**STATE OF DELAWARE / DELAWARE ARMY NATIONAL GUARD
SANITARY SEWER UPGRADES
ADDENDUM #1
February 28, 2013**

CONTRACT NO.: 11-2012

This addendum is hereby made part of the Bid Proposal for the referenced project. Please note the following additions, changes, corrections, and/or information and include the requirements stated herein in connection with this Proposal. Work or materials not specifically mentioned herein are to be as described in the original Bid Proposal Package. This Addendum consists of five (5) items on twenty seven (27) page(s) of text including this page.

BUILDING 135 - SEWAGE GRINDER PLAN

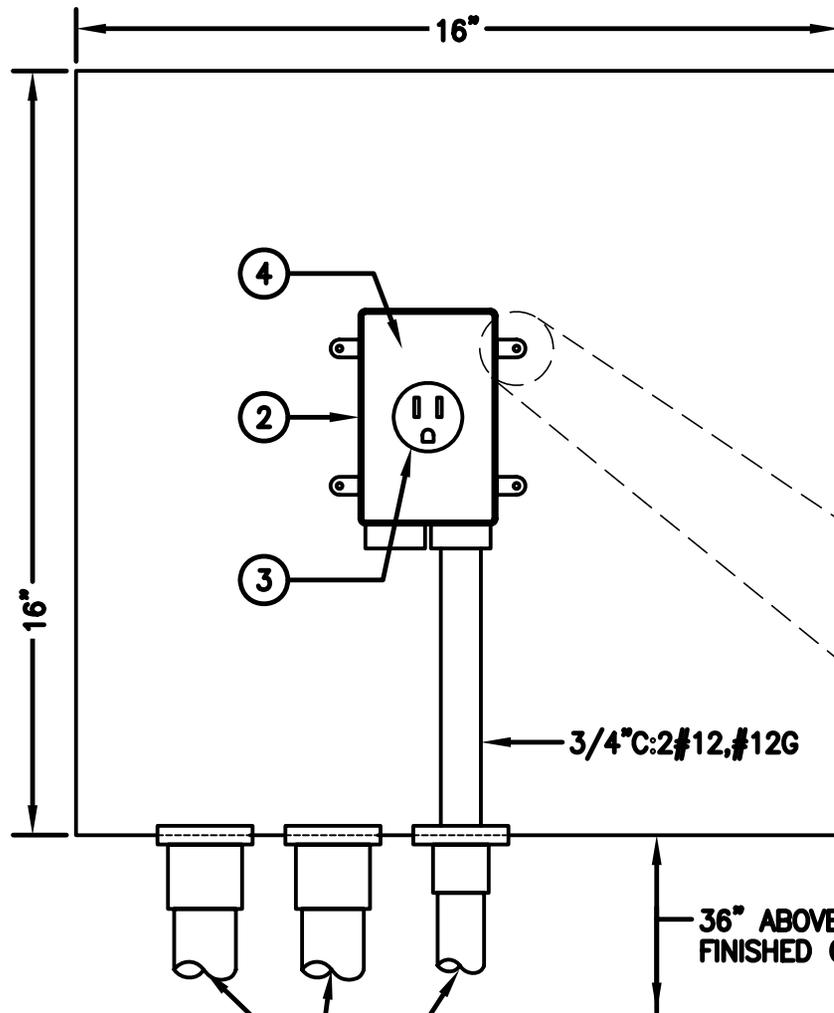
The facility has two (2) Sewage Grinders that are being electrically upgraded under this project. One is located at Building 135 and the other is located at the RV Lot along Bares Lane. The upgrade at each grinder consist of removing the grinder's power receptacle from its vault/wet well and installing a power outlet box above grade with a PVC raceway sleeve for installation of the grinder's power cord and plug. The RV Lot sewage grinder's sleeve will include the float switch cord and interconnect plug. Refer to the four attached drawings of each sewage grinder location and the power outlet detail for the proposed upgrade work.
